TO: Paul Patterson
FROM: David Guntert
CC: Scott McCullough; John Miller
Date: May 8, 2008
RE: Calculations for Z-02-05-08 Protest Petition

Z-02-05-08: Properties in Protest Petition

SOME OF THE PROBLEMS WITH THE PDP FOR UNIVERSITY PARK PLANNED DEVELOPMENT

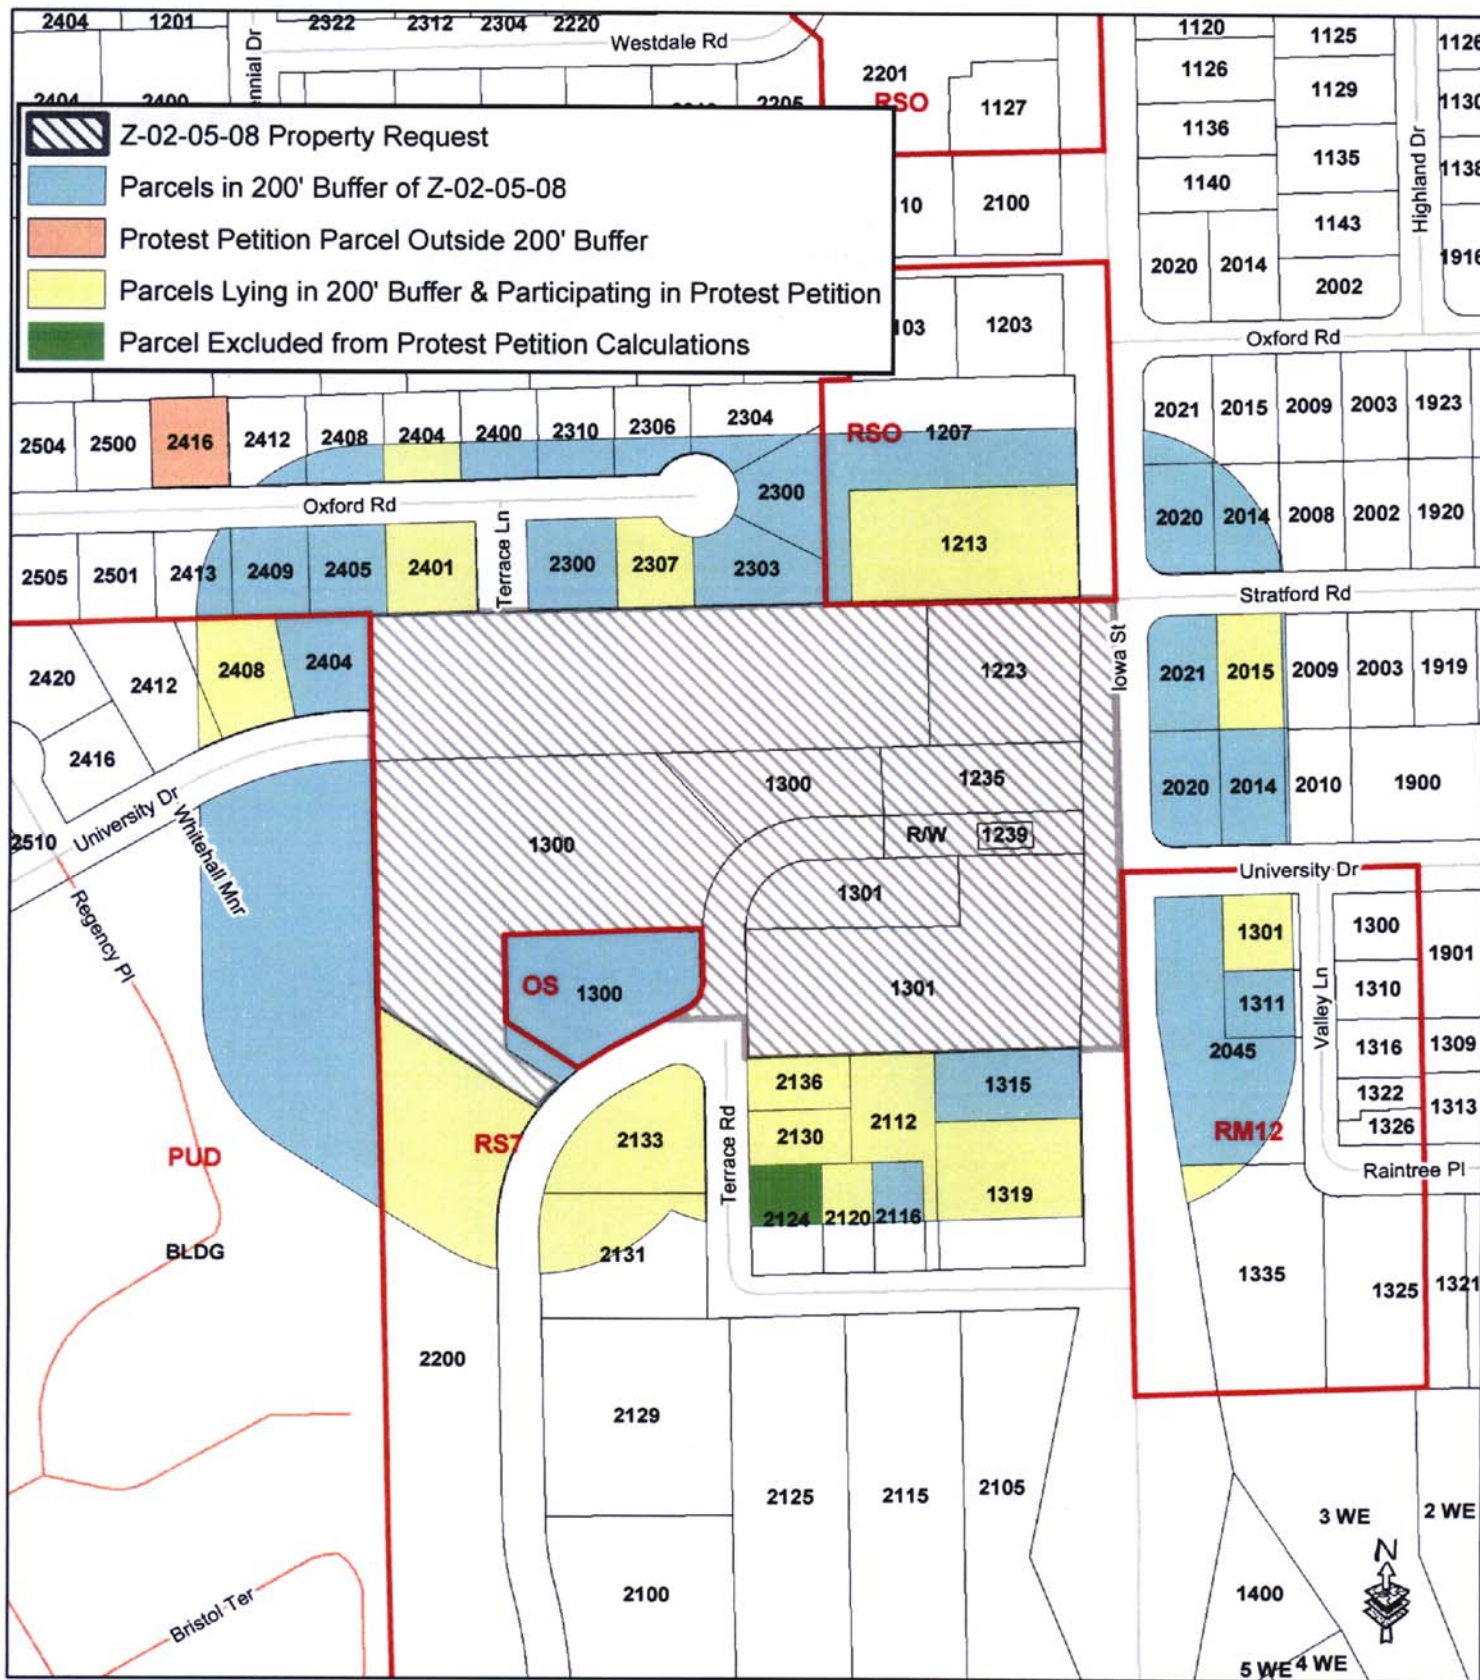
The total area of the real property represented by the fifty-one (51) parcels captured within the required 200 feet notification distance is 12.892 acres. The protest petition was signed by the owners of 19 parcels in the notification area. One of the participating parcels was excluded from the calculations to determine the petition's validity because the petition did not bear the signatures of both record owners as shown on the property ownership list from the Douglas County Clerk's Office. Another property owner signed the protest petition against the zoning change; however their property is beyond the 200' notification buffer and therefore not included in the petition calculation.

The total area represented by the eighteen (18) parcels included in the petition is 4.925 acres or approximately 38.2 % of the real property within the notification area. The petition is valid because it bears a higher percentage than the minimum 20% required by Code to constitute a valid protest petition.
